# SUPPLEMENTAL INSTRUCTION

PROJ.: Turnbull School Music  
Room Addition  
PROJ. No.: 1705  
DATE: November 12, 2018  
S.I. No. S.I. – 003-R1

Retaining Wall and Guard Plan

SI-003.01-R1 – Retaining Wall & Guard Plan

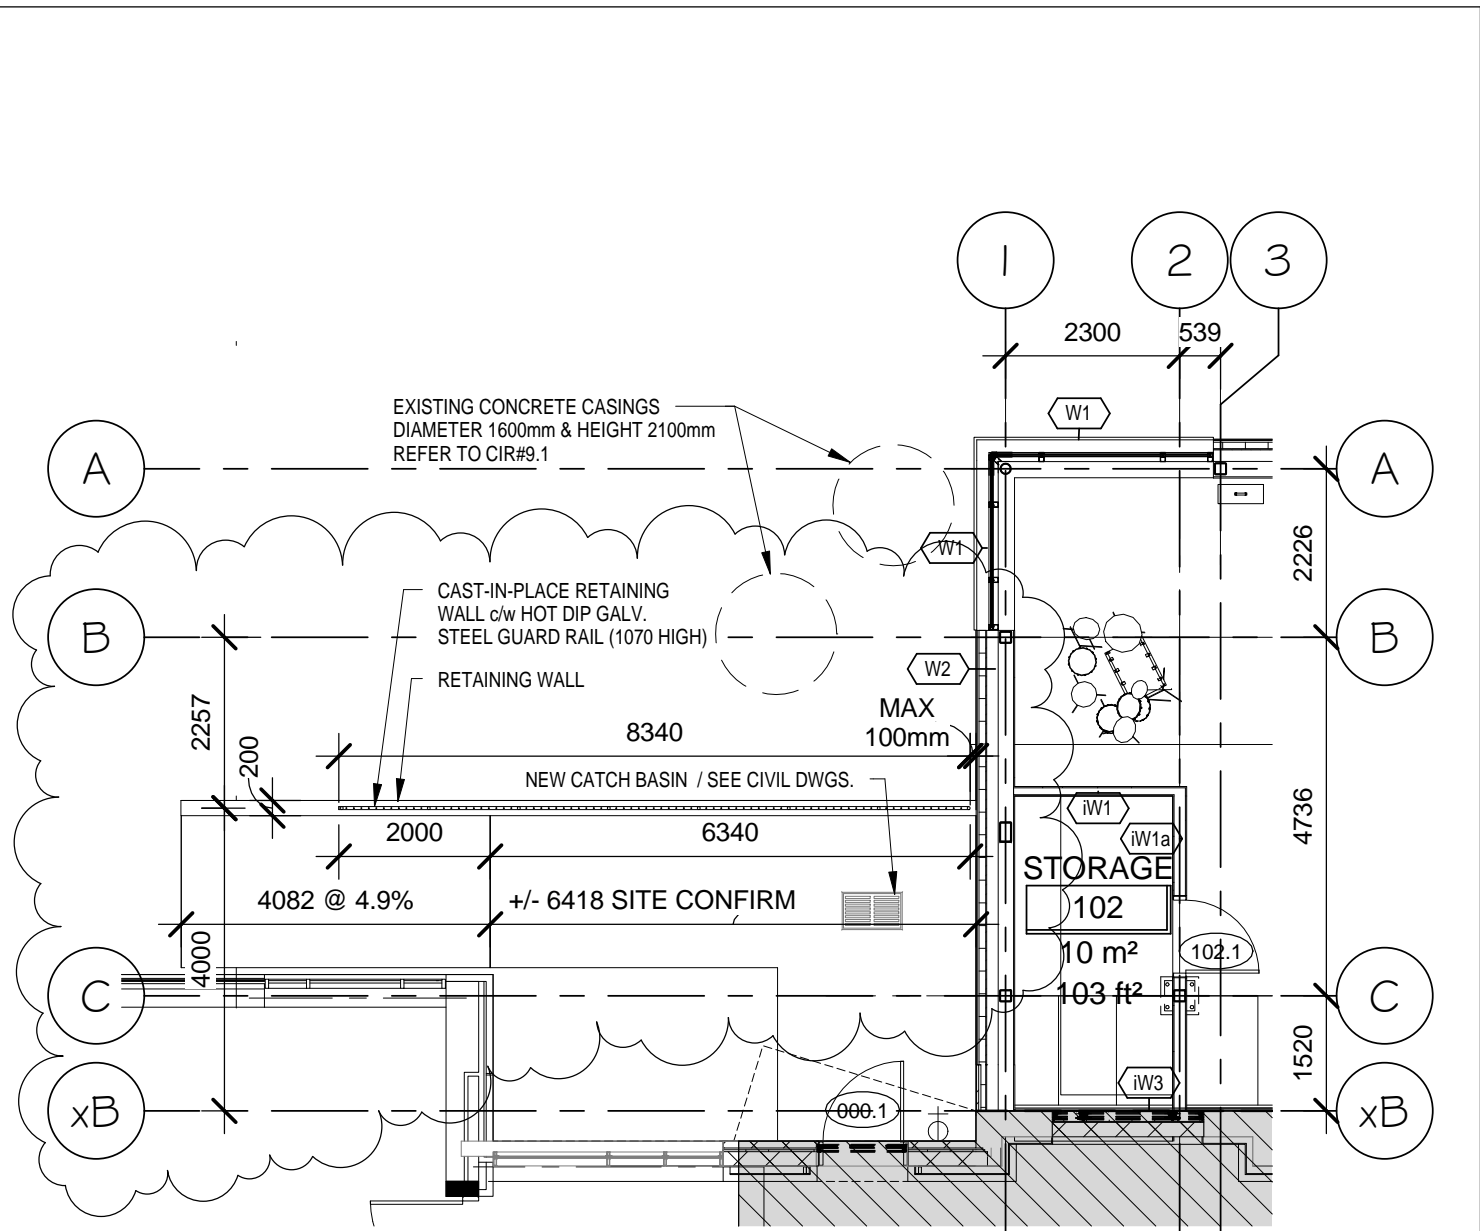
- .1 Refer to the attached Architectural Sketch SI-003.01-R1 for extent of retaining wall and guard rail.
  - .1 200mm wide retaining wall to be 10.5 m in length and centered at 4.0m from grid line xB
  - .2 Guard rail to be 8.34m in length
    - .1 Max spacing of 100mm from end to face of building
    - .2 Extends 2.0m from start of ramp
